SmartCraft Clean Power Harness

Scope

53621

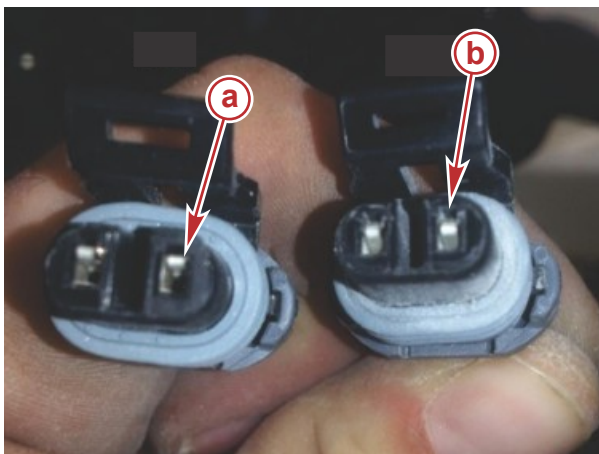
During the manufacturing process some of the female terminals in the clean power 2-pin connector were spread too wide, creating the possibility for either an intermittent electrical failure (occasional engine shutdown), or a complete break in power (engine cannot start, or started then stopped and cannot be restarted). For connectors that were not spread too wide during the manufacturing process, normal electrical component performance and reliability is expected. For connectors that were spread too wide there is a high probability that one of the two electrical failures (intermittent or complete open circuit) will occur either immediately on attempted engine start-up, or very soon thereafter.

a - Bad
b - Good

Correct if any of the conditions described in the **Situation** section are reported by the customer, or observed during setup, inspect the battery connections and replace any clean power harness in the date codes listed if the conditions mentioned in this bulletin are present. Replace with P/N 888416T04.

NOTE: Do not attempt to repair the harness. Replace clean power harness complete.

53622

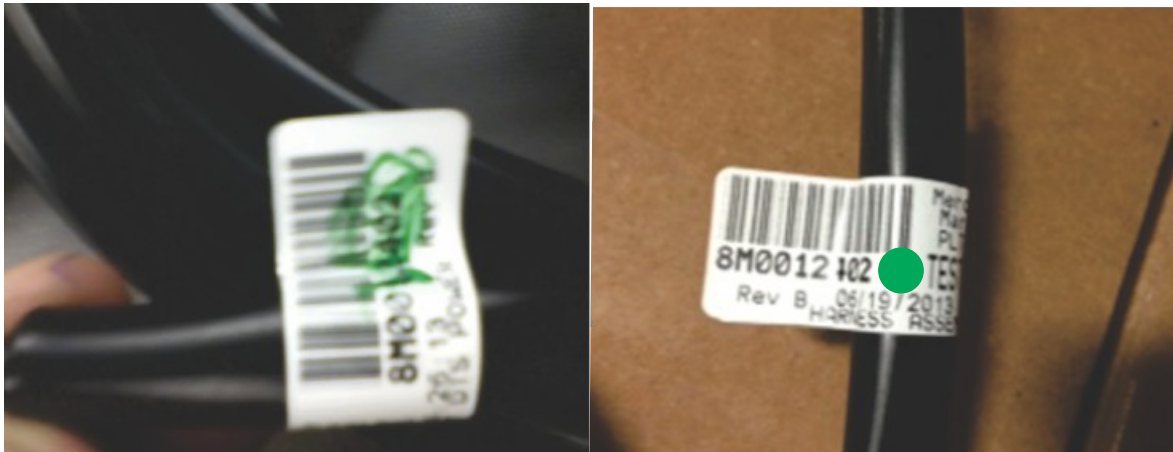
Parts inspected at the factory will have a green mark on the P/N tag.
